The ISO received comments on the topics discussed at the February 28, 2019 stakeholder meeting from the following:

Copies of the comments and economic study requests submitted are located on the 2019-2020 Transmission Planning Process page at:

The following are the ISO's responses to the comments and economic study requests.

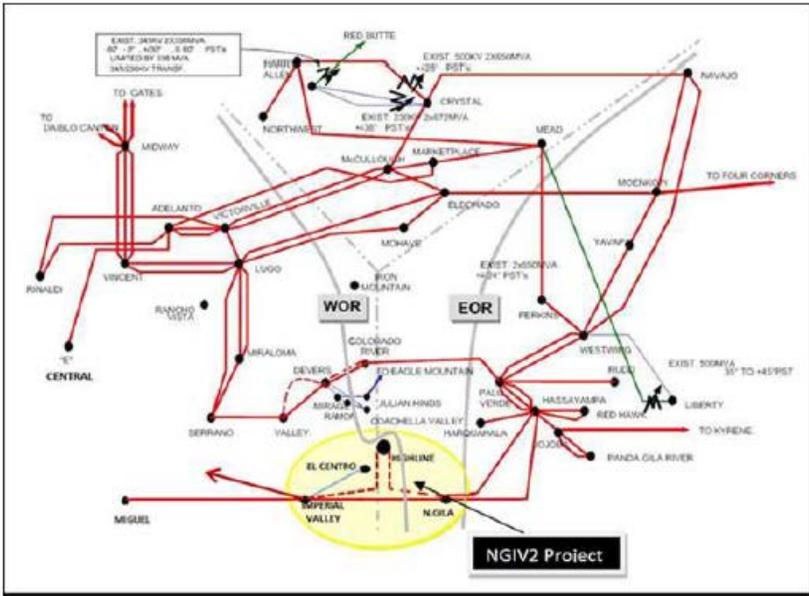
| No | Comment Submitted | CAISO Response |
|----|---|---|
| | <p>can be found within comments LS Power previously filed for 2018/19 Draft Study Plan³ and for 2018/19 Draft Transmission Plan.</p> <ol style="list-style-type: none"> (1) CAISO should provide a timeline by when it expects to conclude whether additional transmission capacity on existing PACI, NOB transmission paths can be made available in the Day Ahead market. This work was taken up by CAISO in the 2018/19 TPP; however there is no information on when CAISO expects to complete it. (2) CAISO's congestion analysis for PACI, NOB, COI paths needs to take a completely different approach this year. CAISO should also study and quantify financial congestion on these paths in addition to physical congestion that it has been quantifying over the last few planning cycles. (3) CAISO should investigate whether its Production cost simulation tool is suitable for capturing financial congestion. CAISO should investigate improving its existing tool or should make use of a different tool so it can correctly capture financial congestion. (4) For the SWIP-North economic study, CAISO should calculate all benefits of a 1000 MW transmission capacity from Midpoint to Harry Allen, free of any wheeling charges. In prior planning cycles, CAISO has only quantified production cost savings but in the 2019/20 TPP CAISO should capture these additional benefits to CAISO ratepayers: <ol style="list-style-type: none"> (a) Financial benefits of improving Day Ahead scheduling capability and thereby alleviating existing Day Ahead financial congestion that is common place for CAISO's PACI, COI, NOB paths (b) GHG reductions and associated savings to CAISO (c) Load Diversity & Flexible Reserve Capacity savings (d) Renewable Capital cost savings. <p>A project such as SWIP-North improves transfer capabilities in/out of CAISO from several neighboring Balancing Authority Areas (BAAs) and hence will provide these benefits. These benefits are typically not captured as part of the TEAM methodology that CAISO uses for its production cost simulation studies. CAISO should conduct separate analyses to quantify these additional benefits.</p> (5) For the SWIP-North economic study CAISO should ensure that the existing transmission path from Robinson Summit to Harry Allen ("ON Line") is limited to 1000 MW in the base case and is increased to 2000 MW only in the case with SWIP-North. As described below, SWIP-North will not only | <p>be evaluated in the 2019-2020 transmission planning cycle will be made later in the year.</p> <p>The comments below will be addressed as we assess the economic study request as a part of the 2019-2020 transmission planning processes based upon the preliminary economic assessment. In regards to the additional transmission capacity on the existing PACI, NOB transmission paths, the CAISO has provided an update in the CAISO response to comments posted on the February 14, 2019 stakeholder meeting on the Draft 2018-2019 Transmission Plan.</p> |

| No | Comment Submitted | CAISO Response |
|----|--|----------------|
| | <p>create a new 2000 MW path from Midpoint to Robinson Summit but a few terminal upgrades associated with the entire build out of SWIP will also increase transmission capacity of ON Line from 1000 to 2000 MW. A total of 1000 MW of transmission capacity from Midpoint to Harry Allen is offered for CAISO use as part of this economic study request. This will effectively move CAISO's BAA boundary station to Midpoint.</p> <p>(6) LS Power is aware of other out of state transmission projects that are in development. A few of these projects, such as Boardman to Hemingway and Gateway West, compliment benefits of SWIP-North. While CAISO may choose to study a few scenarios that combine SWIP-North with one or more of these projects, this Economic Study requests evaluation of SWIP-North as a standalone project.</p> | |
